OFFICER'S REPORT FOR:

Independent Hearing Commissioners

Variation 1 Rezonings

Peter Wilson

Figure 2 Connecting up cul-de-sacs with secondary connectors.

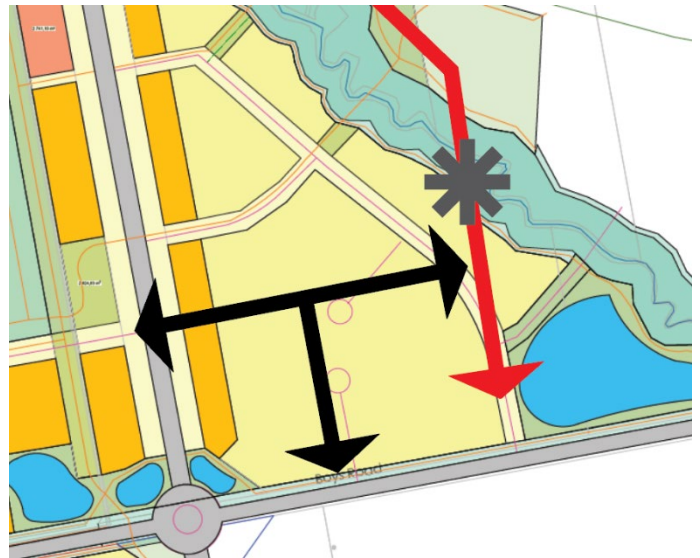
- The concept plan shows two cul-de-sac heads within a large block to the eastern side of the proposal. The blocks dimensions are unclear however the scale is significant and will not

promote good walking and cycling through the block. It is recommended that the cul-de-sacs are joined to create a through road with traffic calming measures. This will allow greater pedestrian access and promote healthy active lifestyles.

Figure 3 Potential orthogonal layout with additional connection over Boys Road

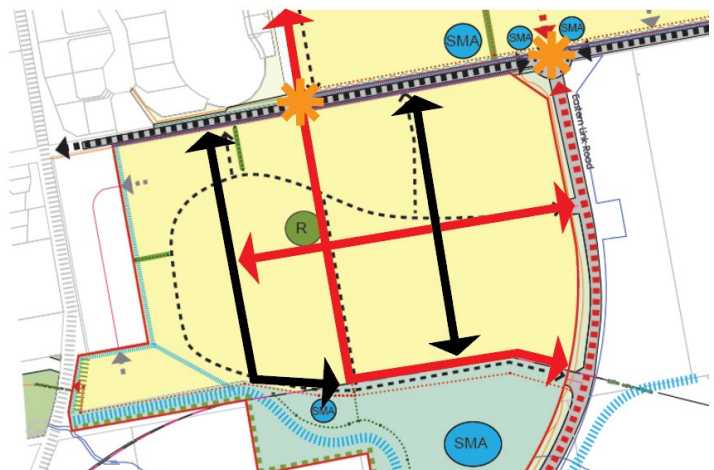
- The railway line provides a barrier to connectivity east-west and restricts connectivity between future neighbourhoods in the proposed ODP with established neighbourhoods in Southbrook. The proposed shared cycle and pedestrian pathway which connects east-west is therefore supported and a safe crossing over the rail line is assumed part of the ODP development. The pathway will be an important connection between the Southbrook community including the Southbrook School and Rangiora New Life School and future neighbourhoods within the proposed ODP area.

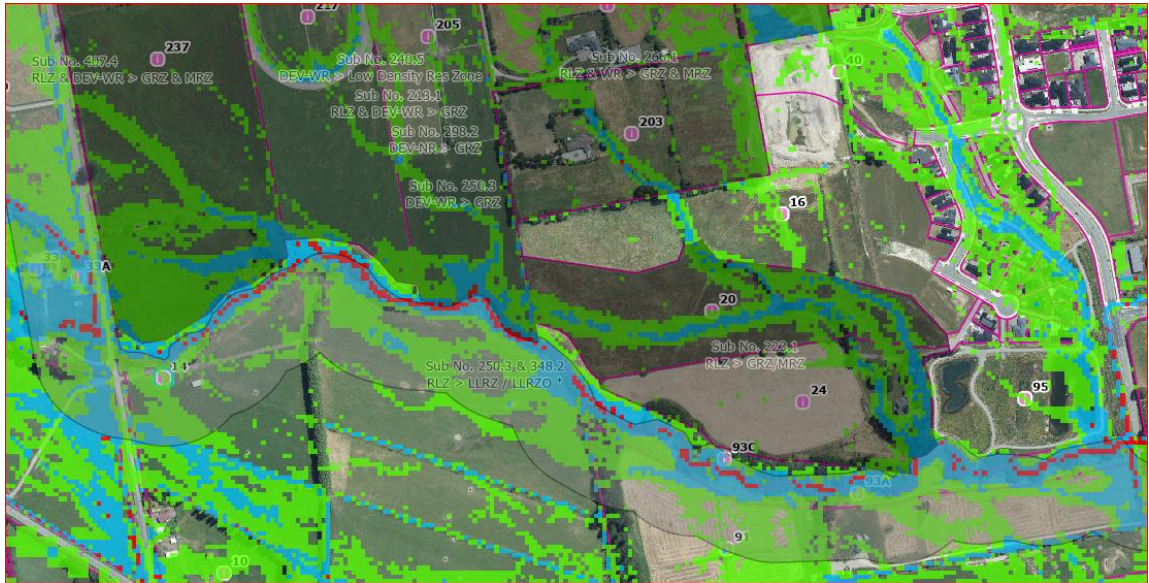
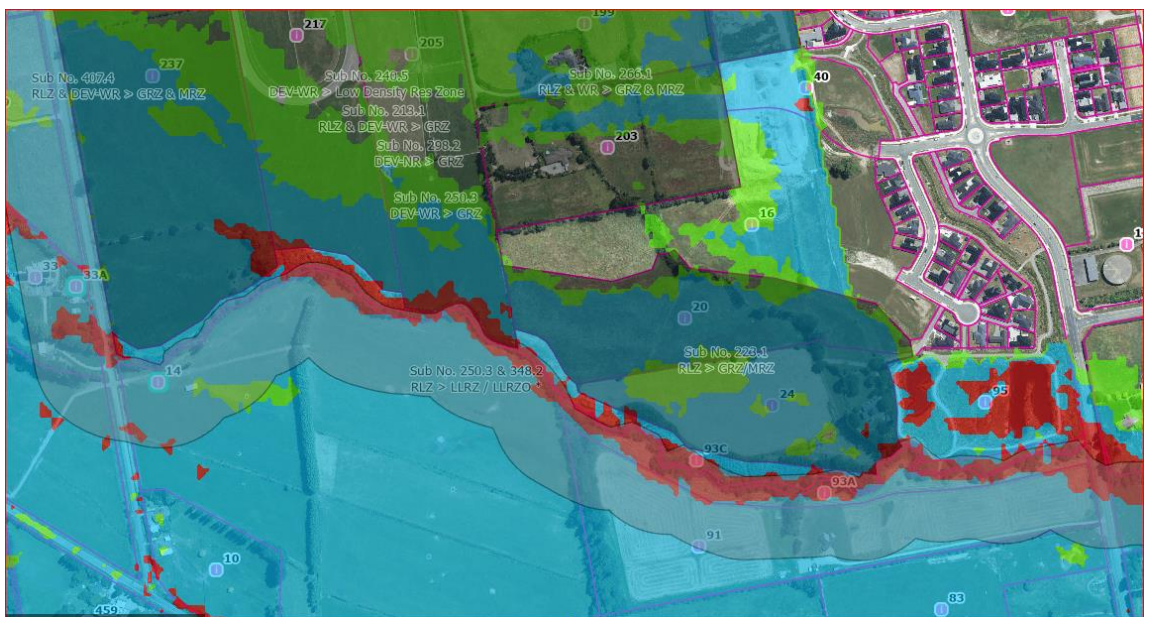
- 302. The southern part of the ODP site is susceptible to flooding.
- 303. Modelling indicates there are relatively narrow areas of low to medium flood hazard that are largely confined to various alluvial depressions and shallow stream channels in a 200yr local flood event. Refer below;

- 304.
- 305. Importantly, the extent of the flood hazard increases substantially to a medium to high flood hazard in the Breakout Flooding Hazard 200yr scenario, with approximately half of 237 Johns R (s407) and virtually all of 20/24 Angus PI (s233) modelled to have a medium flood hazard. Only the far south part of 205 and 217 Johns Rd have a medium flood hazard, with the main mid and north parts of these two sites having a low to very low flood hazard in the Breakout scenario. Refer below:

Figure 1 - 200 year Model Results

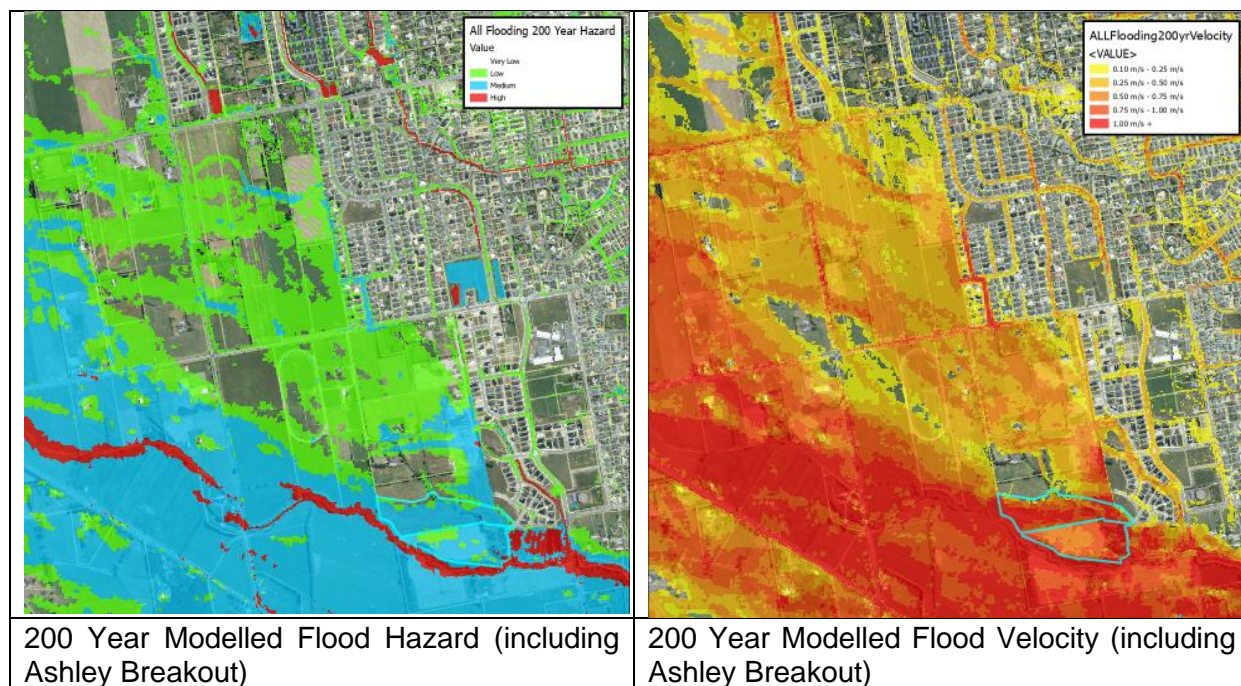
These properties are both under the flowpath from an Ashley River breakout and are shown as having significant areas of Medium Flood Hazard in both the 200 year and 500 year flood events. Under an Ashley River breakout scenario both parcels of land would be subject to significant flood velocities exceeding 1.0 m/s. Refer to Figure 1 for the model results.
